UNITED STATES PATENT AND TRADEMARK OFFICE

APPLICATION NO.	FILING DATE	FIRST NAMED INVENTOR	ATTORNEY DOCKET NO.	CONFIRMATION NO.
10/580,859	03/01/2007	Walter Viegner JR.	102475.57672US	8826

Office Action Summary	Application No. 10/580,859	Applicant(s) VIEGNER ET AL.	
	Examiner STEPHANIE JENNINGS	Art Unit 4135

DETAILED ACTION

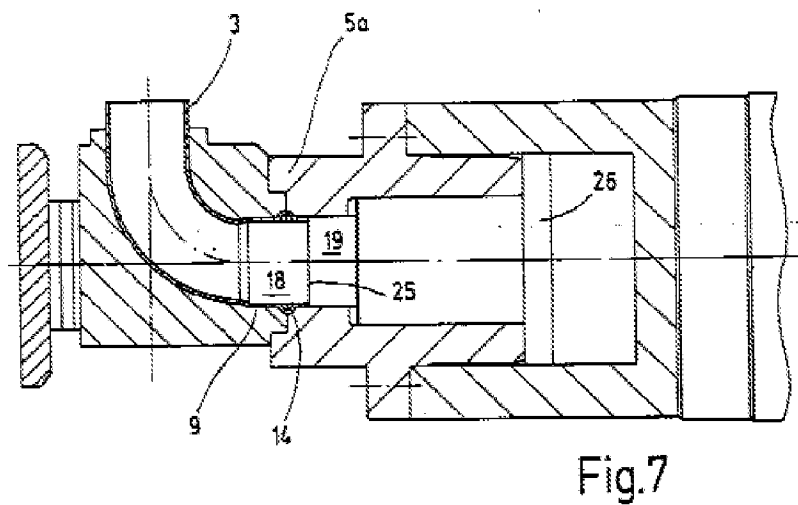
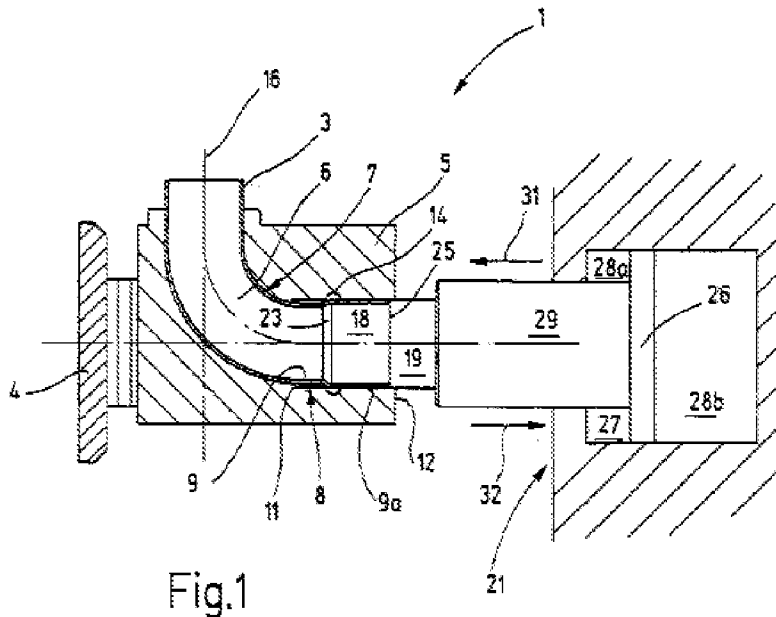
14. Viegner anticipates:

15. Limitations from claim 9, a method of making a socket on a pipe made of copper, by an at least single-step expansion of a pipe end with a large jump in diameter, comprising: introducing an expansion tool (18, 19, 21, 5, figure 1) axially into the pipe end (9), and at least partially upsetting a region to be expanded of the pipe end simultaneously with and/or

subsequently to introduction of the expansion tool into the pipe end by a force applied axially to the pipe end while limiting an outer diameter of the pipe end to be processed by at least one shaping shoe (5) at least partially surrounding the pipe end (page 1, paragraphs 3 and 10, page 2, paragraphs 11-12, and page 3, paragraph 34).

18. Limitations from claim 16, an apparatus for making a socket on a pipe end, comprising: an expansion tool which is axially introducible into the pipe end and which has one or more conical and cylindrical parts (8, figure 1) adapted to determine a subsequent inner diameter of the pipe end, at least one shaping shoe (5) having conical and cylindrical parts adapted to determine a subsequent outer diameter of the pipe end, and a substantially cylindrically structured upsetting

device (8, figure 1) having a smallest inner diameter which corresponds, with necessary play, to a maximum outer diameter of the expansion tool and a substantially radially extending annular shoulder which is pressable axially against an end face of the pipe end during an upsetting step (page 1, paragraphs 3 and 10, page 2, paragraphs 11-12, and page 3, paragraph 34).

19. Limitations from claim 17, the apparatus as defined in claim 16, wherein, on its side oriented toward the pipe end (9), the expansion tool has a cylindrical part which adjoins the shoulder and having an inner diameter which determines the greatest diameter of that enlarged outer diameter of a cylindrical part of the pipe end which is reached after the upsetting step (page 2, paragraph 16).

20. Limitations from claim 18, the apparatus as defined in claim 17, wherein the inner diameter of the cylindrical part (8, figure 1) corresponds to a maximum inner diameter of the at least one shaping shoe (5, figure 1) (page 2, paragraph 16).

21. Limitations from claim 19, the apparatus as defined in claim 17, wherein an axial length of the cylindrical part (8, figure 1) is greater than or equal to a length of a cylindrical part of a shaping shoe (5, figure 1) which has a largest inner diameter (page 2, paragraph 17).

22. Limitations from claim 20, the apparatus as defined in claim 15, wherein an axial length of the cylindrical part (3, figure 1) is greater than or equal to a length of a cylindrical part of a shaping shoe (5, figure 1) which has a largest inner diameter (page 2, paragraph 17).

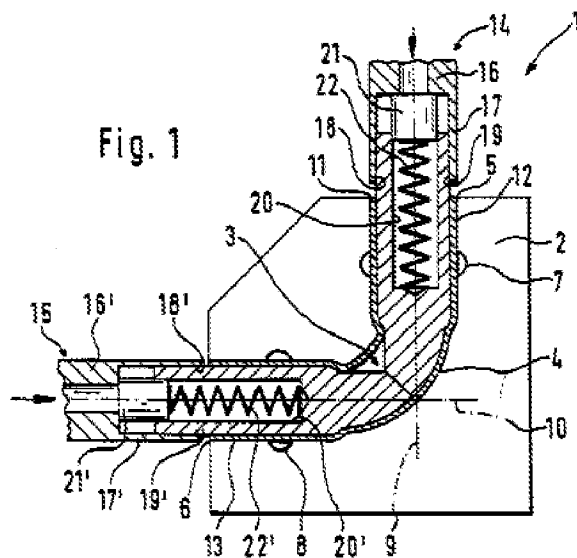
34. Viegner teaches:

35. Limitations from claim 12, the method as defined in claim 9, wherein the upset pipe ends (12, 13, figure 1) are inwardly flanged for receiving sealing elements (93b, figure 1) (column 1, line 62-column 2, line 5).

36. Limitation from claim 14, the method as defined in claim 10, wherein the upset pipe ends (12, 13, figure 1) are inwardly flanged for receiving sealing elements (93b, figure 1) (column 1, line 62-column 2, line 5).

37. Limitations from claim 15, the method as defined in claim 11, wherein the upset pipe ends (12, 13, figure 1) are inwardly flanged for receiving sealing elements (93b, figure 1) (column 1, line 62- column 2, line 5).

38. It would have been obvious to one of ordinary skill in the art at the time of invention to combine Viegner's invention with Viegner's invention because inwardly flanging the ends of

the upset pipe allows for easier sealing during forming and ensures a more secure seal after the sealing elements are attached.
